# CROSSROADS MIXED USE FILING NO. 1

## COUNTY OF EL PASO, STATE OF COLORADO STORM SEWER PLANS

UNDERGROUND DETENTION  
DECEMBER 2022

CROSS ROAD MIXED USE FILING NO.1		TITLE SHEET		DATE: 12-23-22		SHEET 1 OF 6		SI01	
PROJECT NO. 18-003		SCALE: HORIZONTAL: N/A VERTICAL: N/A		DESIGNED BY: GT		DRAWN BY: TAU		CHECKED BY: VAS	
212 N. WAHSATCH AVE., STE 305 COLORADO SPRINGS, CO 80903 PHONE: 719.955.5485									
FOR AND ON BEHALF OF M&S CIVIL CONSULTANTS, INC.		VIRGIL A. SANCHEZ, COLORADO P.E. NO. 37160							
REVISED:	NO.	DATE:	BY:	DESCRIPTION:	DATE:	BY:	DESCRIPTION:	DATE:	BY:
THE ENGINEER PREPARING THESE PLANS WILL NOT BE RESPONSIBLE, OR LIABLE FOR, UNAUTHORIZED CHANGES TO OR USES OF THESE PLANS. ALL CHANGES TO THE PLANS MUST BE IN WRITING AND MUST BE APPROVED BY THE PREPARER OF THESE PLANS.									
CAUTION

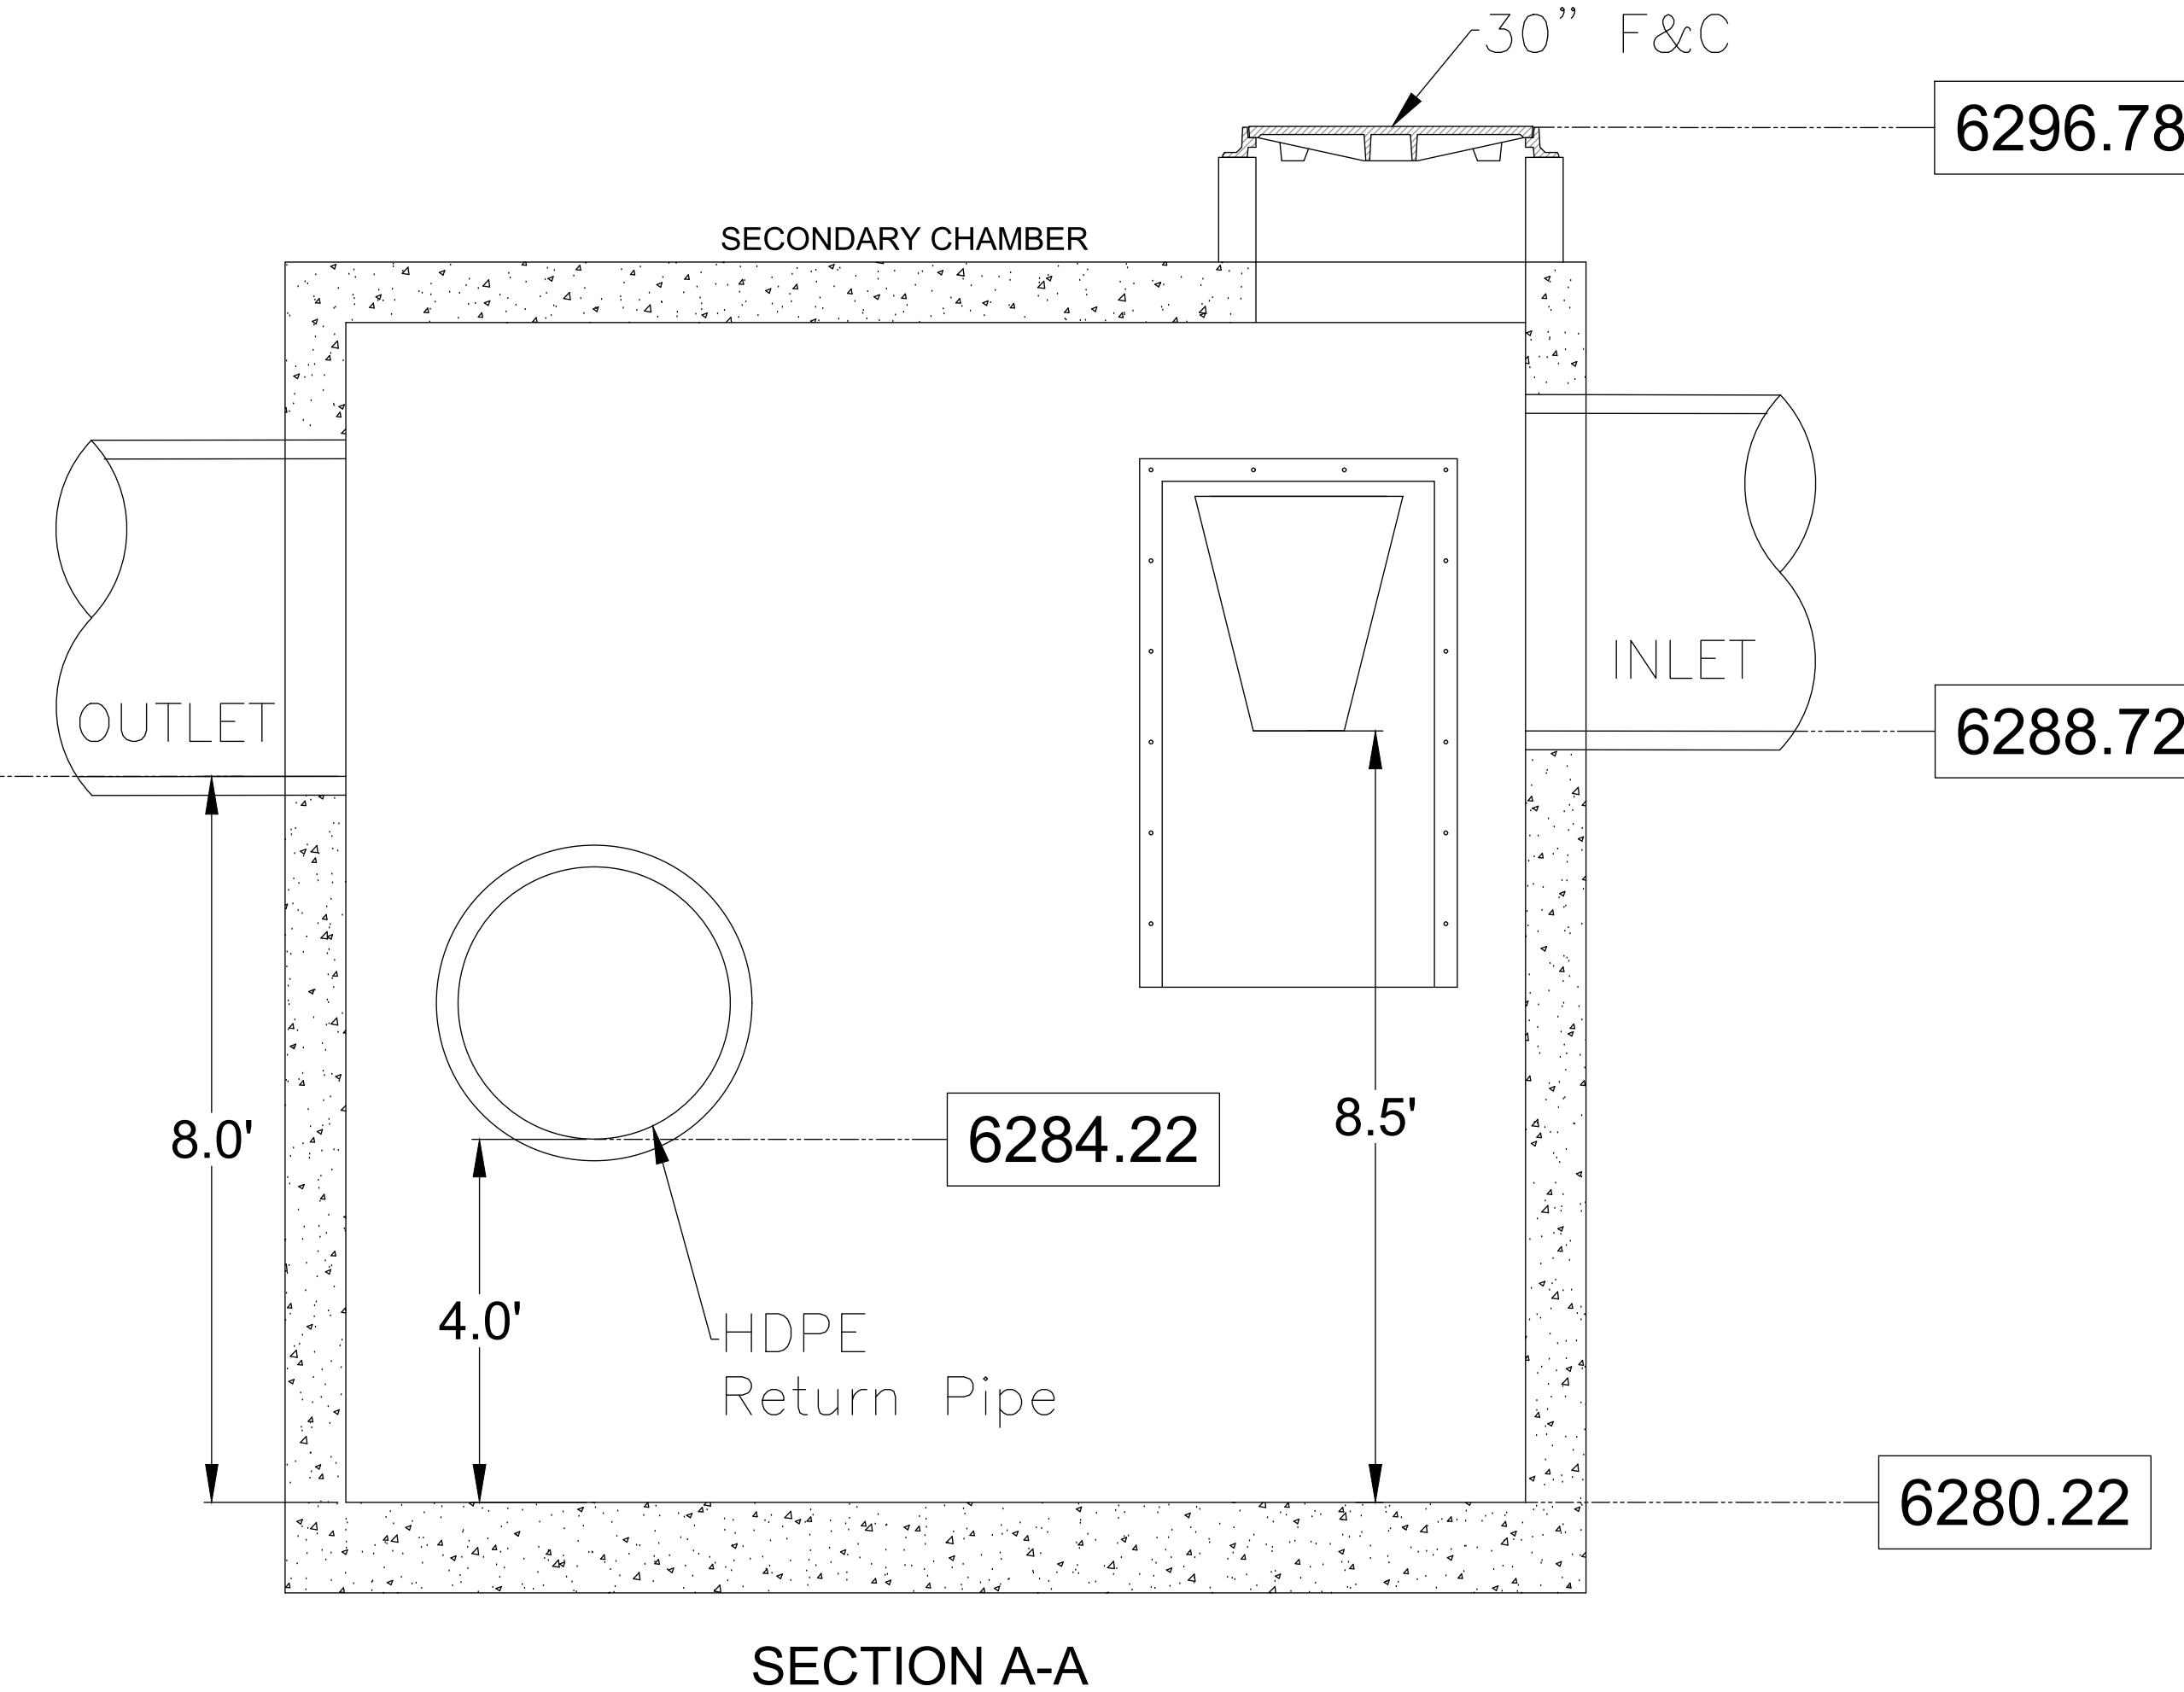
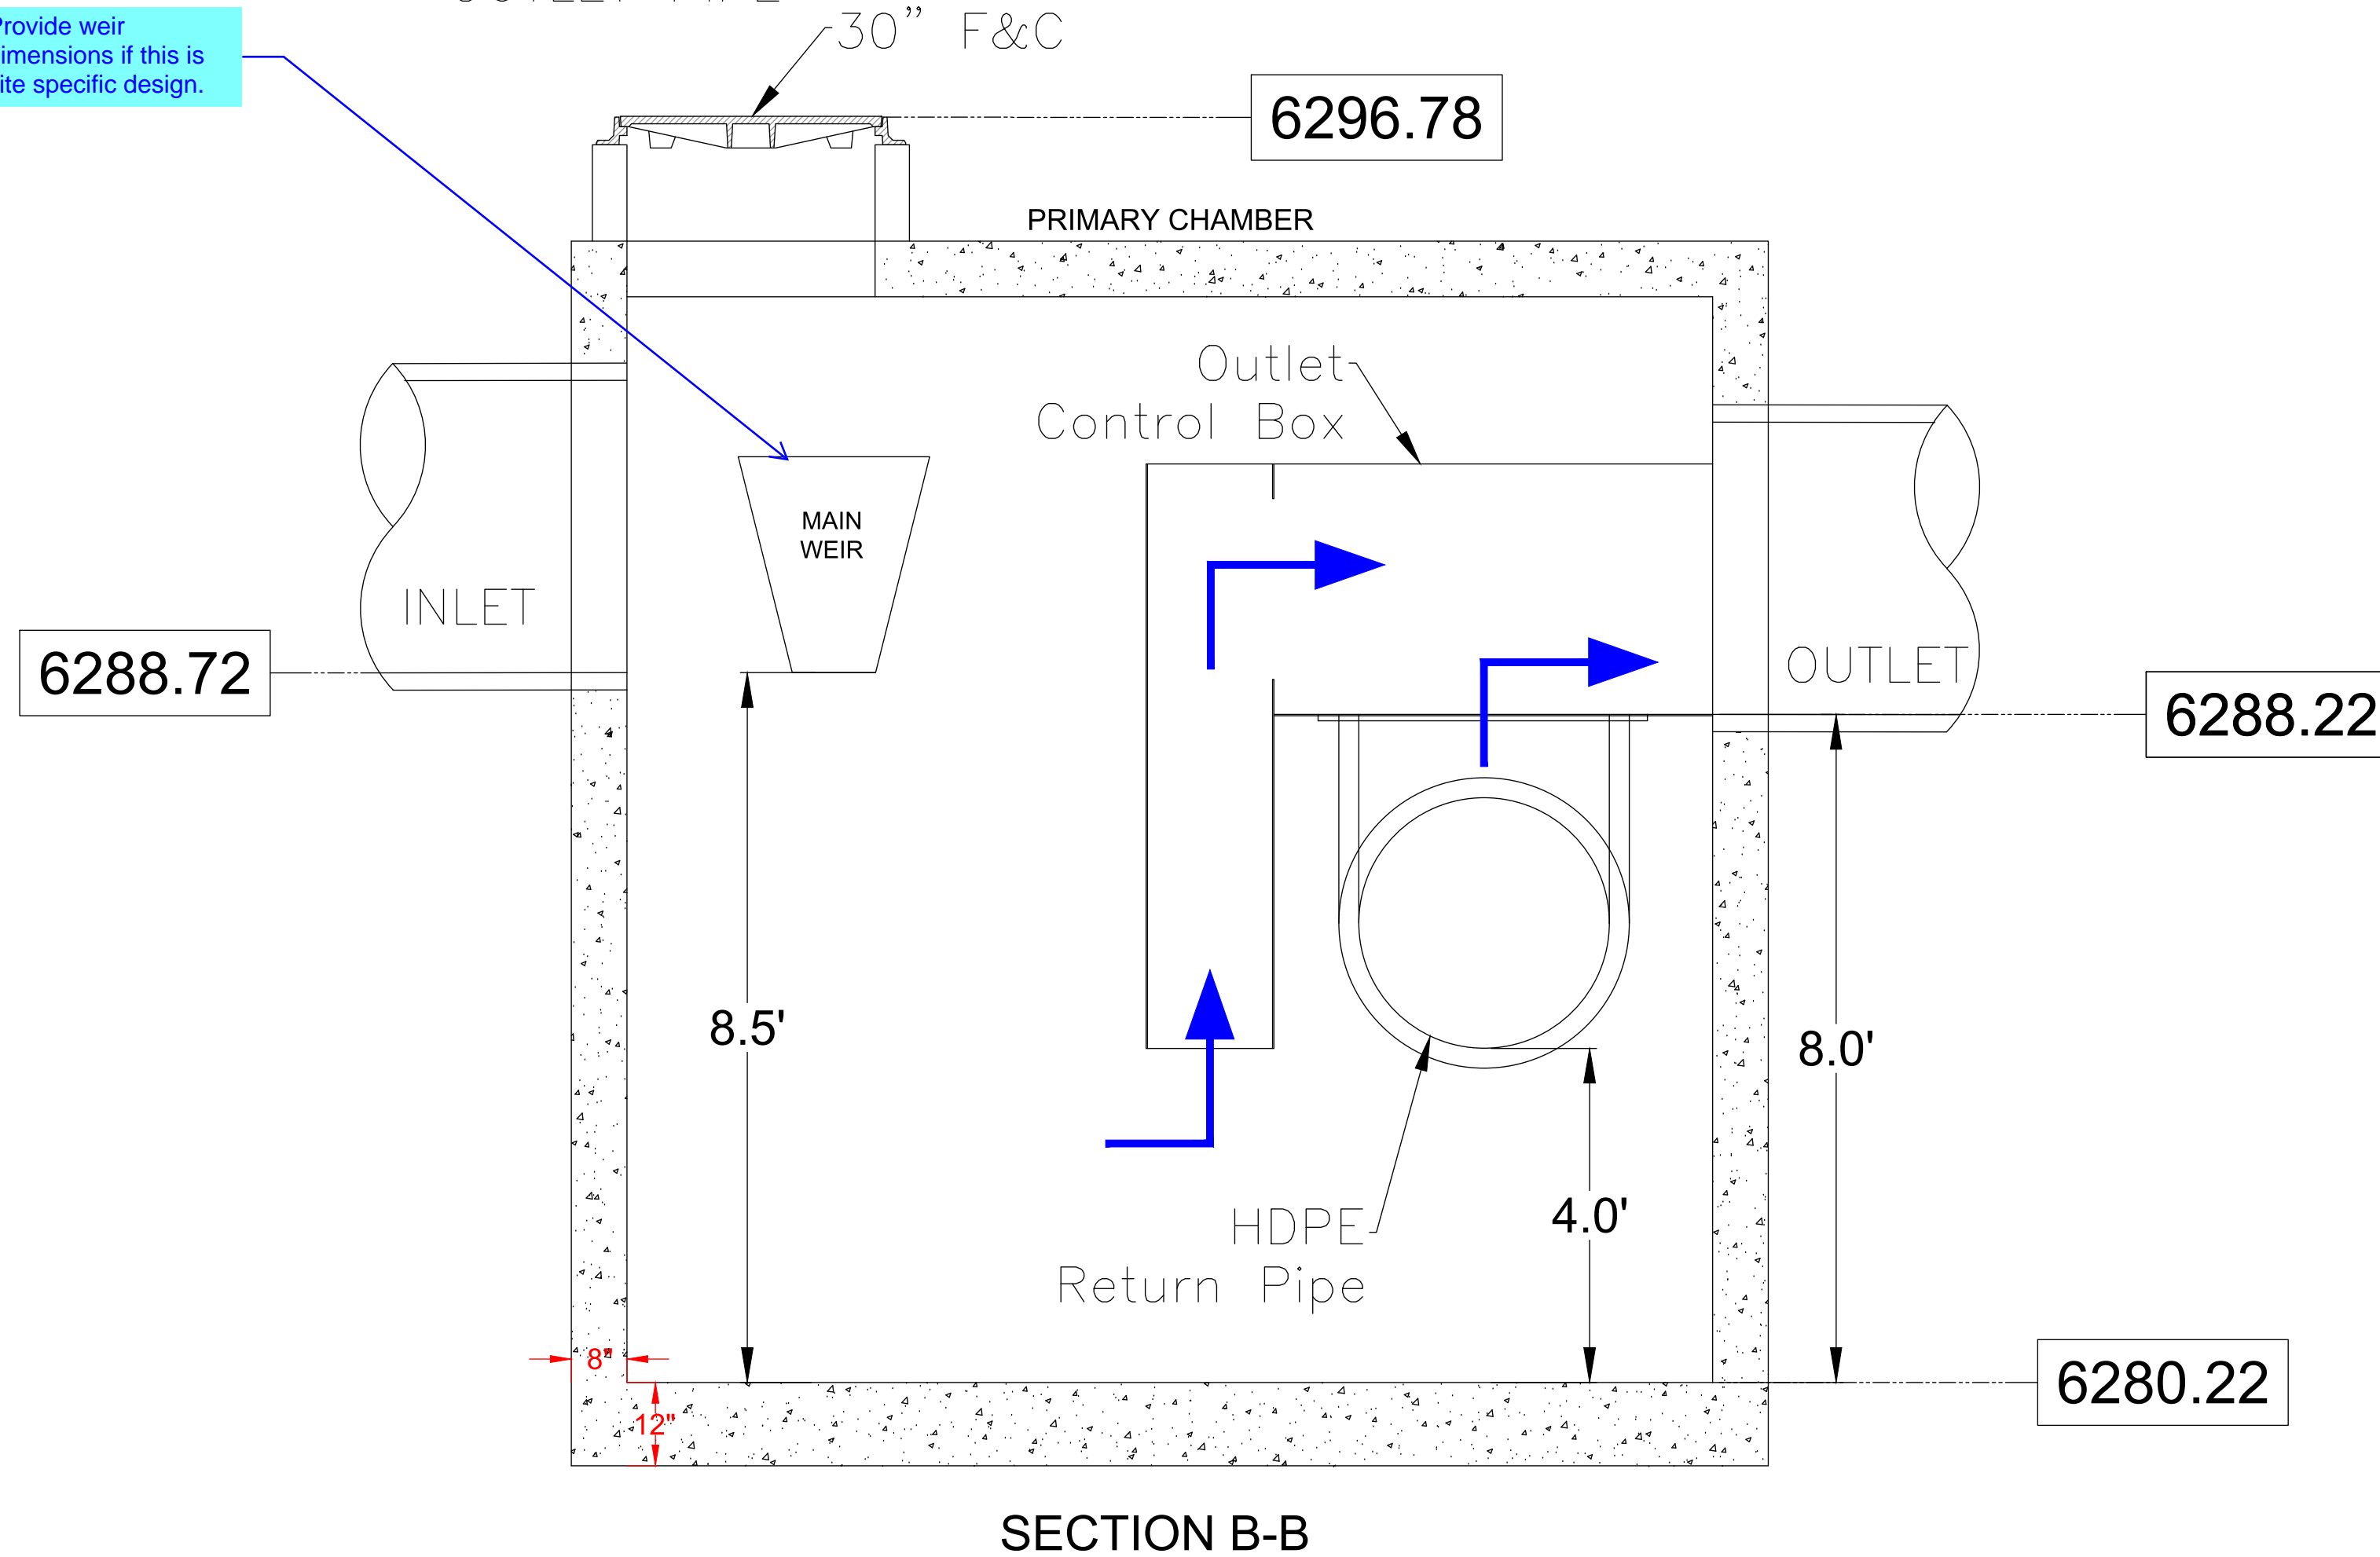
Provide and show the location and details for the steps to access the interior of the structure.

Provide weir dimensions if this is site specific design.
